# Recall Bulletin

## F/CMVSS NONCOMPLIANCE RECALL

**SUBJECT:** Transmission Shift Cable Adjuster Body Fracture

**MODELS:** 2014 Buick Enclave, LaCrosse, Regal, Verano  
2014 Chevrolet Cruze, Impala, Malibu, Traverse  
2014 GMC Acadia

3723122

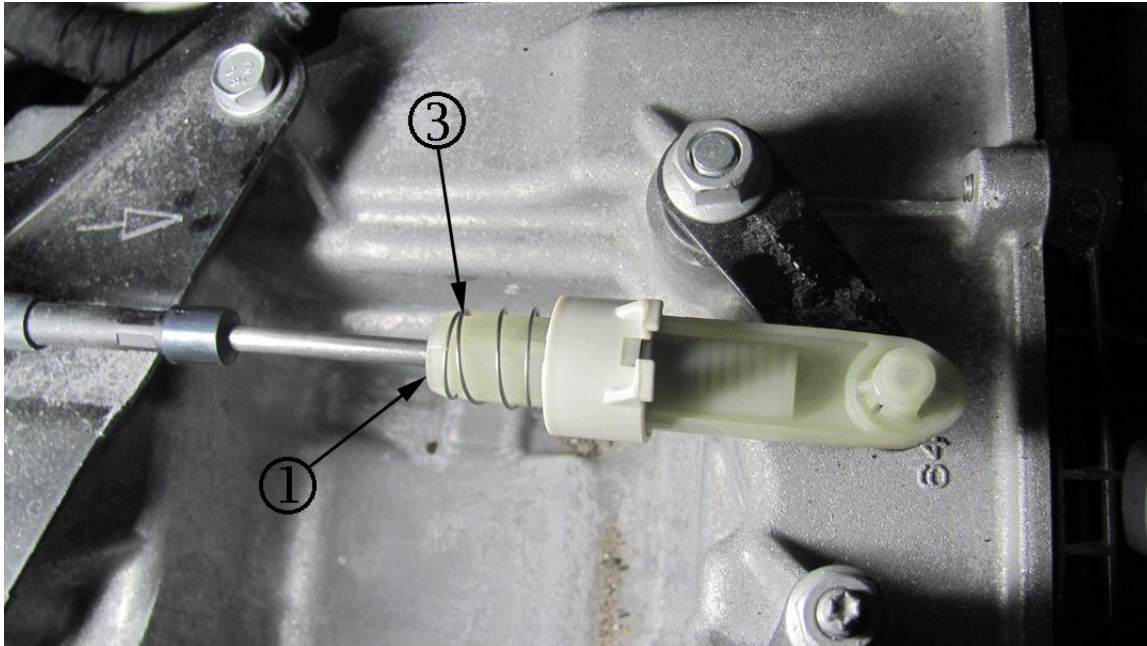
A first design shift cable adjuster body (1) is black and the lock clip is white (2). Refer to the 'A' portion of the photograph. A second design shift cable adjuster body is white and the lock clip is black. Refer to the 'B' portion of the photograph.

2. Determine what design shift cable adjuster body and lock clip are installed on the vehicle.
  - If the vehicle is equipped with a first design shift cable adjuster body and lock clip (A), no further action is required. A first design shift cable adjuster body is black (1) and the lock clip is white (2).
  - If the vehicle is equipped with a second design shift cable adjuster body and lock clip (B), proceed to step 3. A second design shift cable adjuster body is white (1) and the lock clip is black (2).
3. Ensure the transmission range selector lever is in the PARK position.
4. Ensure the transmission shift lever is in the PARK position.

Dealers are to inspect and, if necessary, replace the factory installed white shift cable adjuster body and black lock clip with a black shift cable adjuster body and white lock clip.
